January 6, 1982
G02-82-03
SS-L-02-CDT-82-001

Subject: NUCLEAR PROJECT NO. 2
SUBCOMPARTMENT PRESSURIZATION

Issue 37

Subcompartment Pressurization

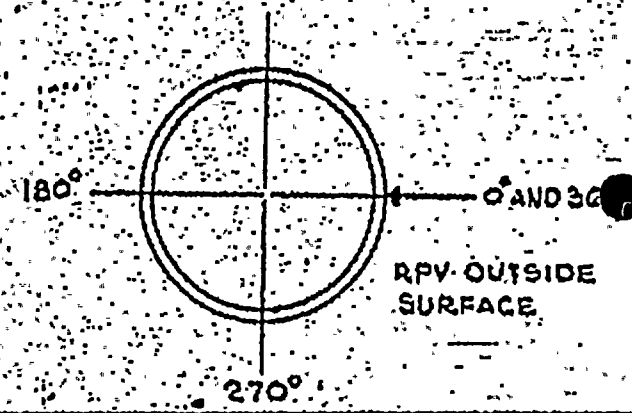
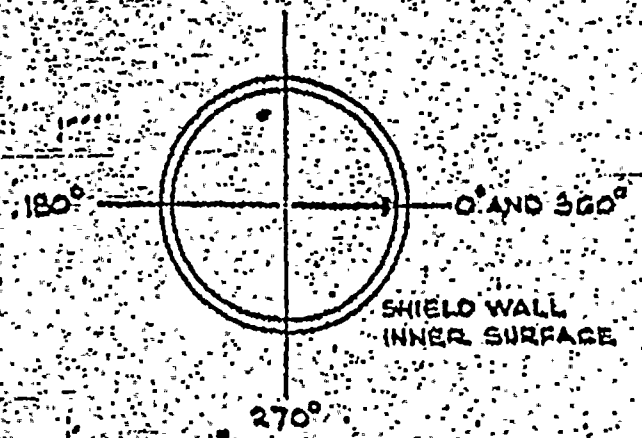
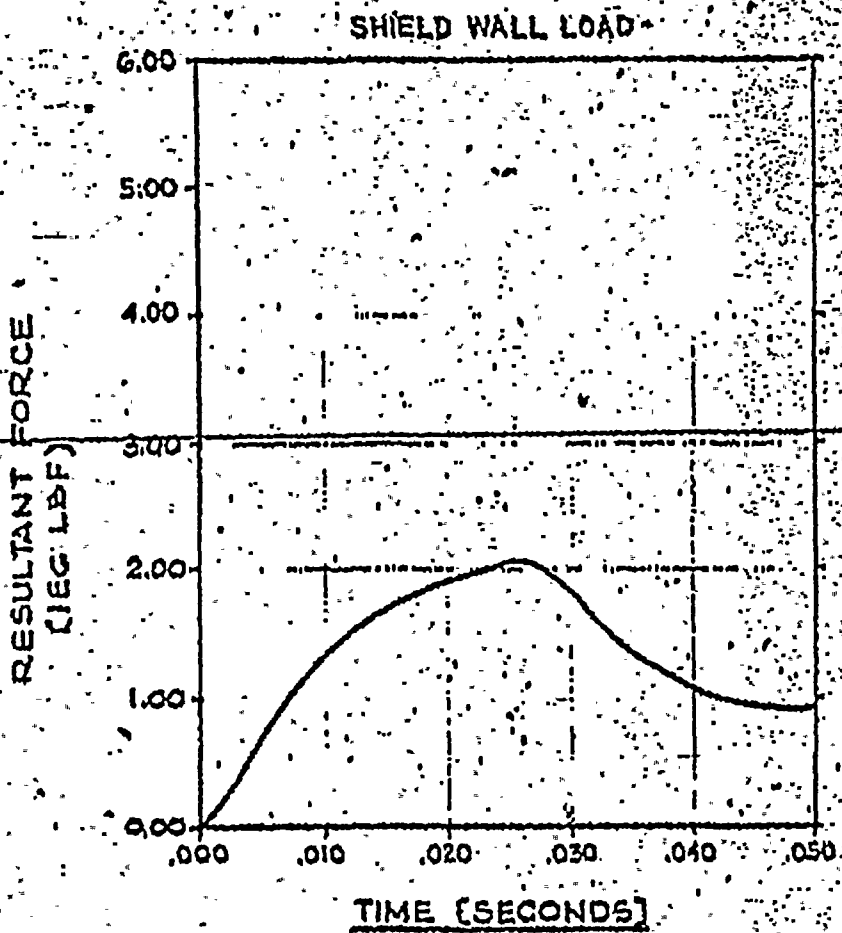
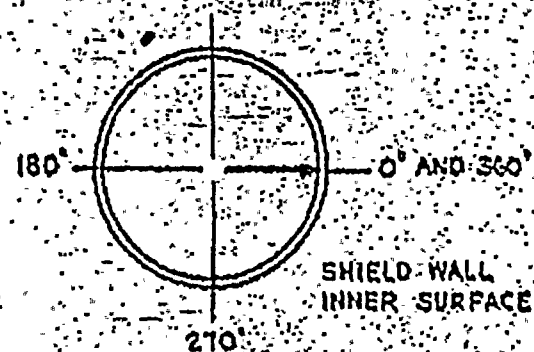
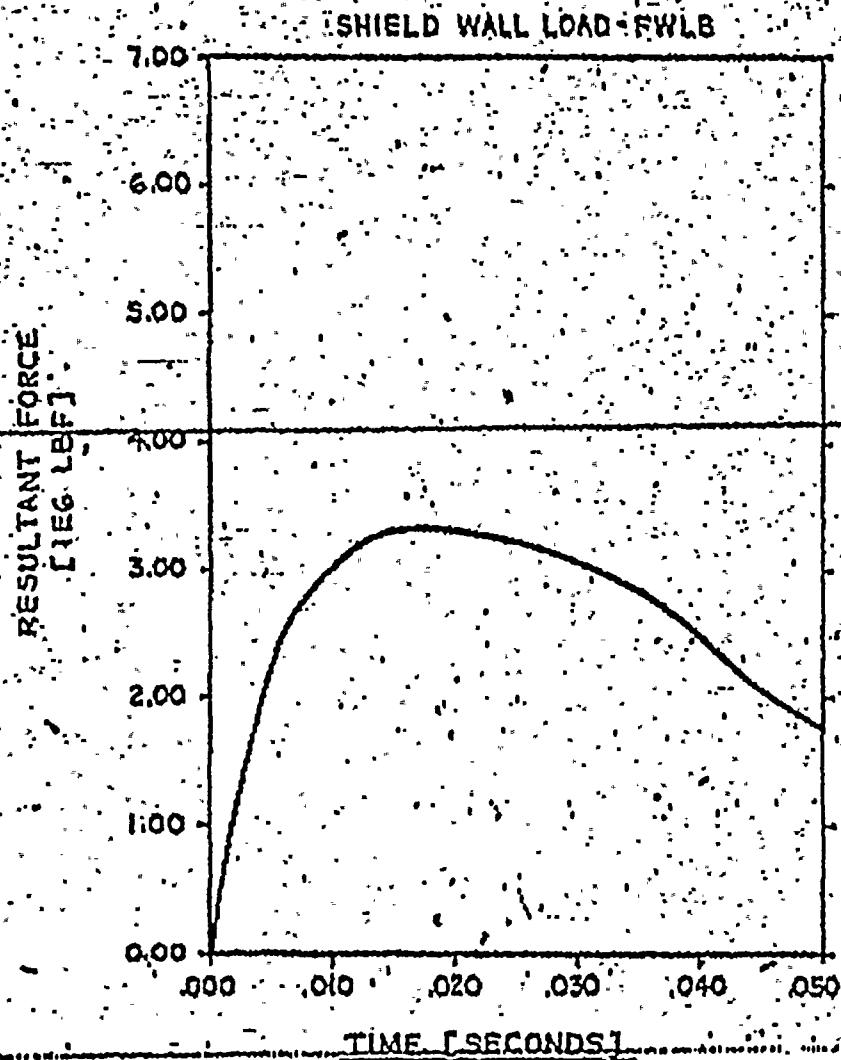
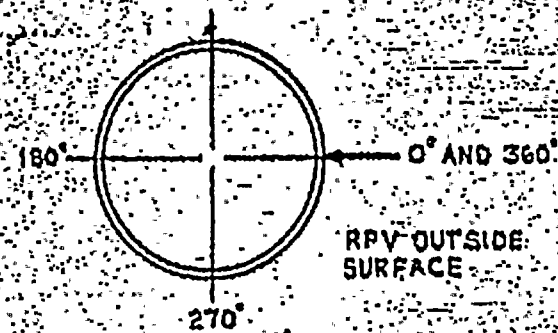
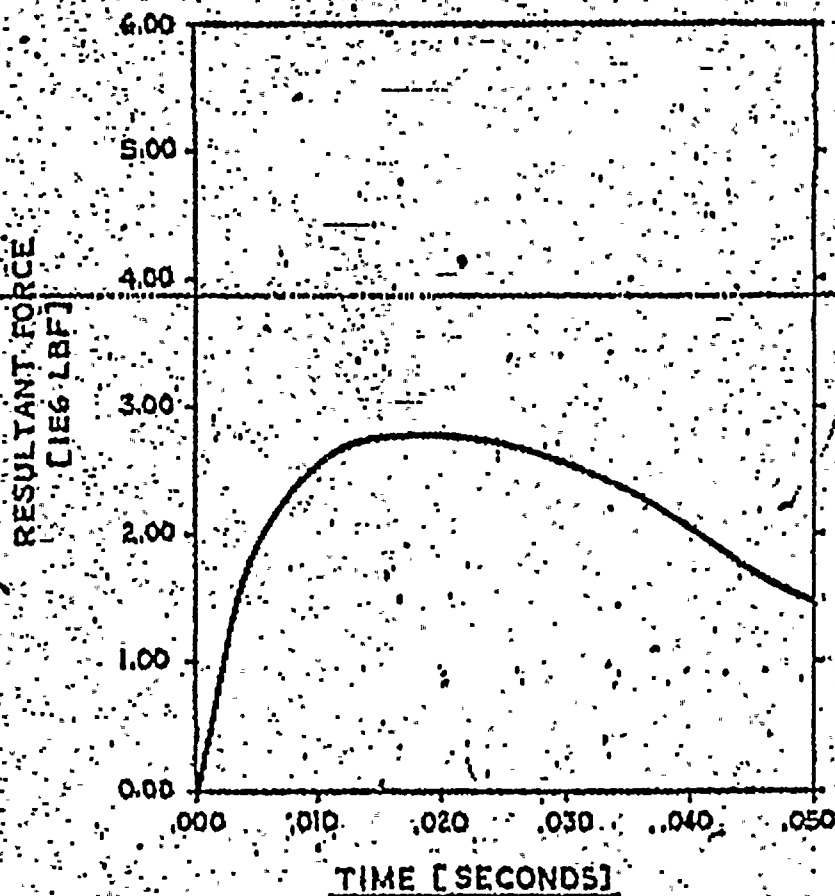
Subcompartment Pressurization. In telephone communication on 11/19/81, NRC requested additional information related to Issue #37. In the response to Issue #37 WNP-2 provided plots of lateral force as a function of time using current state-of-the-art methods employed by the industry for these calculations. In the telephone communication NRC requested plots of lateral force as a function of time based on the older, more conservative methods used in 1975/76 to calculate these loads. These older, more conservative calculations were used for the evaluation of the major structures.

Included in Figures 1-4 are plots of the lateral forces as a function of time for the original annulus pressurization loads. The force is calculated by taking the vector sum of the product of the compartment pressure and area for each of the nodes in the nodal model. Figures 1-4 are provided for comparison with results calculated by NRC; in practices analyses for annulus pressurization are performed by directly applying pressure-time-histories to the structural model rather than by using an intermediate calculation of this type. (Please see Pages 16-22, and Figure 6B of Report WPPSS-74-2-R2-B, Reference 6.2.11 in the FSAR.)

The older, more conservative approach, as represented by Figures 1-4, was used for the design of the major affected structures, i.e., the sacrificial shield wall and the RPV/pedestal connection design, as indicated in revised 6.2.1.2 or the WNP-2 FSAR.

The project has utilized the older, more conservative pressurization loads for the NSSS evaluation.
